**From:** Schmidt, Eric <Eric.Schmidt@aecom.com>  
**Sent:** Friday, July 17, 2020 6:38 AM  
**To:** Richard, Philip E - DNR  
**Cc:** 'Bradley.S.Nave@chemours.com'; Pooler, Cary; Saari, Christopher A - DNR  
**Subject:** Barksdale - Soil Stockpile Update  
**Attachments:** Use Area PAT Stockpile Photos\_07.06.2020.pdf; Use Area PAT Stockpile Photos\_07.13.2020.pdf

The WDNR has reviewed the addendum letter for the Former Dupont Barksdale Works Site dated May 18, 2020. This email serves as an approval to your exemption request under NR 718.05 with the following considerations:

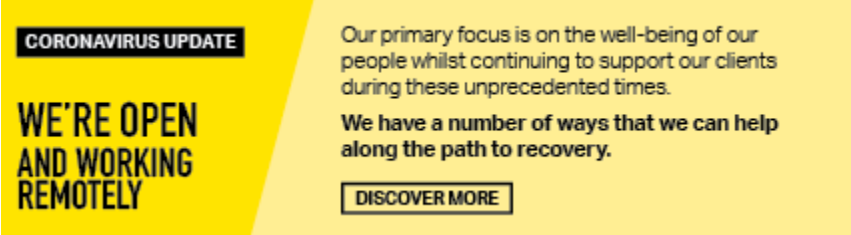
-Is there any water run-off from the material? It didn't appear there was from the picture, but it didn't show the entire area. Can you send a couple more pictures that show more of an overview of the area?

1. No, there is no free liquid running off the material. Additional pictures are attached.
2. Yes, we will monitor the stockpile as it dries and send you an update and corresponding pictures weekly.

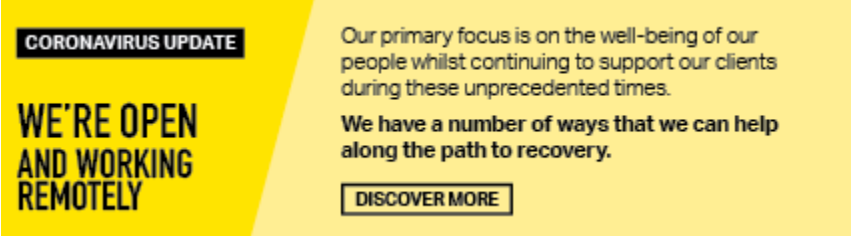
The material we are receiving is too wet to meet the requirement in NR718.05 that stockpiled soil be "...sloped and graded to eliminate depressions in the surface..." (see attached photos). We are requesting WDNR approval to leave the material uncovered until it is dry enough to be graded. A cover would be applied at that point.

You may leave the material uncovered until it is dry enough to work with.
